JOINT REGIONAL PLANNING PANEL (Southern)

JRPP No	2017 – STH014
DA Number	DA No. 205 / 2014 (Part 5) Reference DAM0029 / 2017
Local Government Area	Shellharbour
Proposed Development	Section 96(2) modification application which seeks an amendment to the deferred commencement development consent granted by the JRPP at its meeting of 20 October 2014, specifically: B30 Realignment of Cygnet / Minga Avenue Intersection
Street Address	Lot 2 DP 1091265 Cygnet Avenue, Shellharbour City Centre
Applicant	Savills Project Management
Owner	Shellharbour City Council
Number of Submissions	NIL
Regional Development Criteria (Schedule 4A of the Act)	The Panel was the consent authority for the original DA. Clause 21(1)(a), Part 4 of State Environmental Planning Policy (State and Regional Development) 2011
List of All Relevant s79C(1)(a) Matters	<ul style="list-style-type: none"> • Shellharbour Local Environmental Plan 2013 • Shellharbour Development Control Plan 2013

Assessment Report and Recommendation Cover Sheet

Figure 2: Traffic movements in the future PM peak (Source: J. Wyndham Prince)

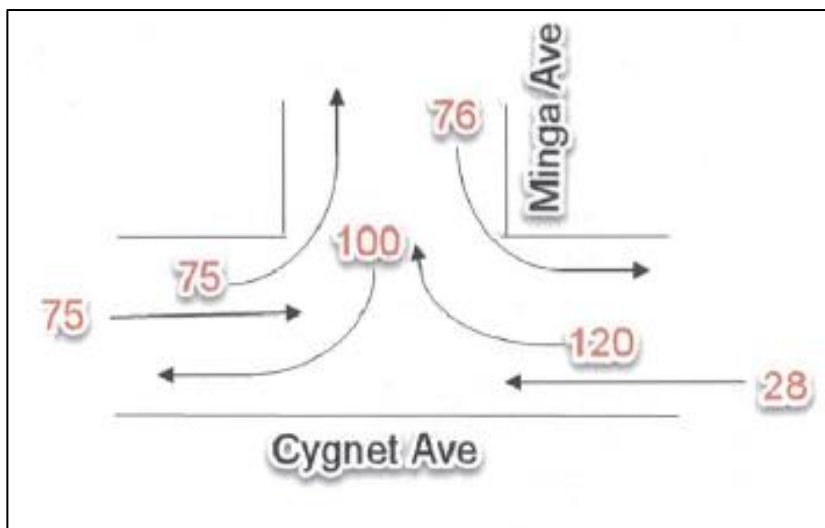
The Design Report suggests that the delay to vehicles waiting to turn right from Cygnet Avenue would increase queue length of vehicles in the proposed right turn bay.

Figure 3: Relationship of the intersection to the Civic Centre entry / exit (Source: J. Wyndham Prince)

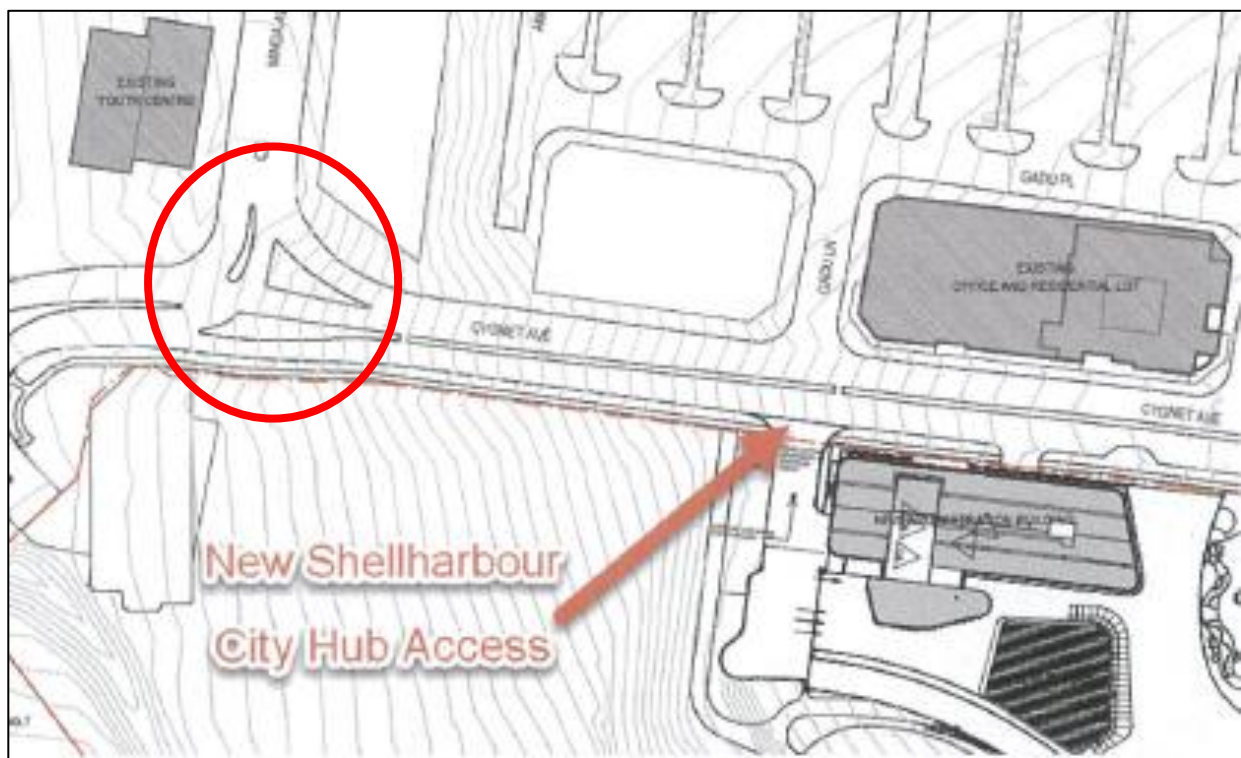
The Design Report anticipates that vehicle queuing would extend into the westbound through lane in Cygnet Avenue, possibly causing congestion and potential for rear end collisions.

Proposed Intersection Upgrade Road Design Pavement Plan

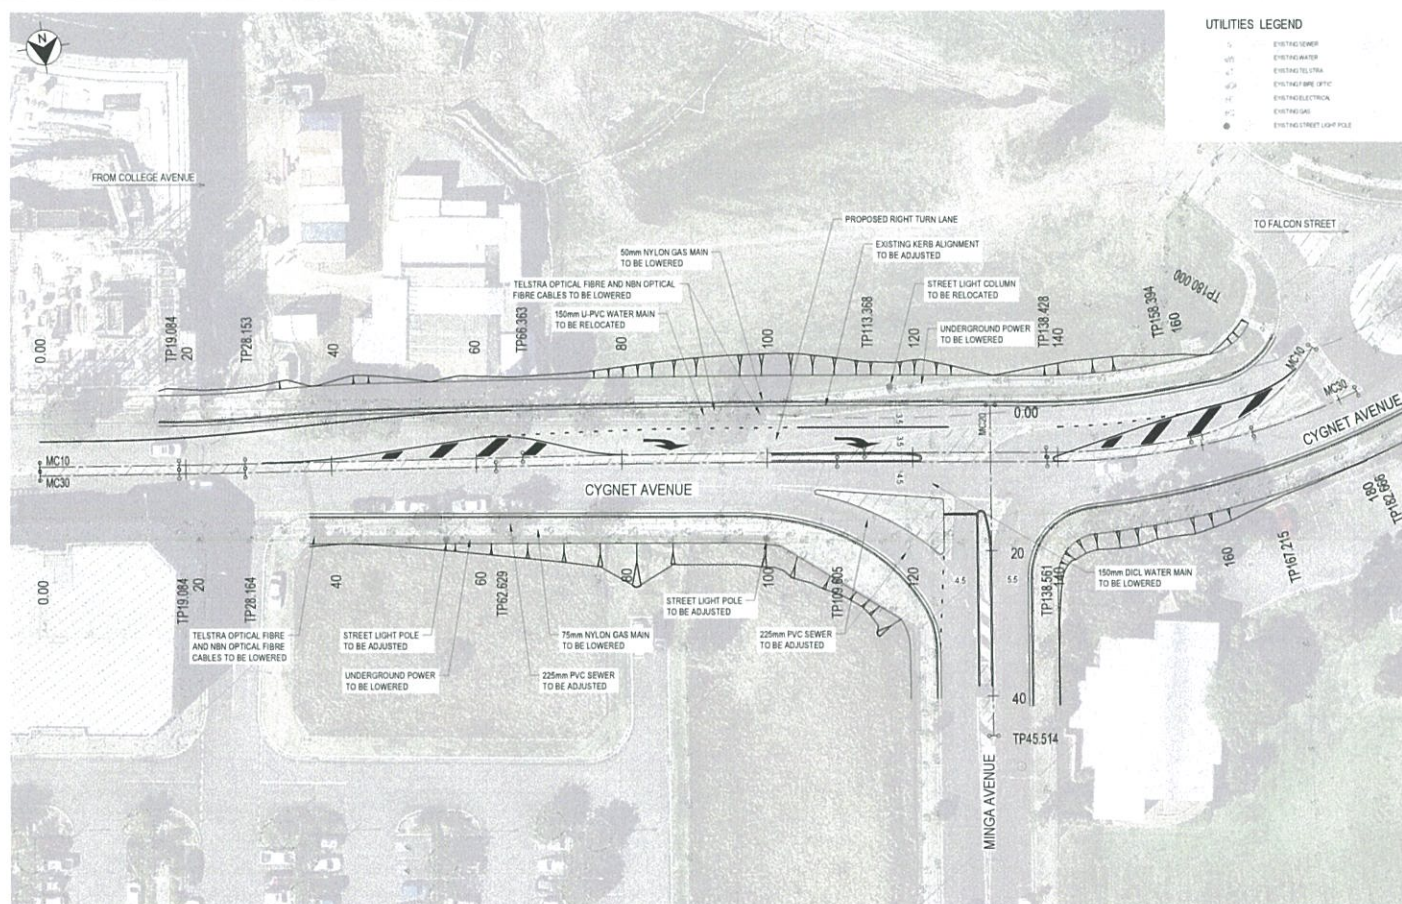
The Design Report indicates that the existing slope in Cygnet Ave exceeds recommended cross fall standards and requires significant re-grading and realignment to achieve appropriate safety levels for heavy vehicles. The flow-on effects are documented on the Drawing at **Attachment 1** and include:

- Relocation and adjustments to utility services including water, sewer, electricity, communications and gas;
- Widening of the Cygnet Ave road reserve (land area of approx. 95m²) which would also necessitate cut and fill batters to accommodate new levels;
- Impact on the Youth Centre on the NW corner of the intersection which would require level adjustments (including the construction of a retaining wall) and the reconstruction of the existing access driveway;
- 4 existing kerb inlets would also require adjustment; and
- Consequential batters within the privately owned property on the north eastern corner of Minga Avenue and Cygnet Avenue to support the realignment.
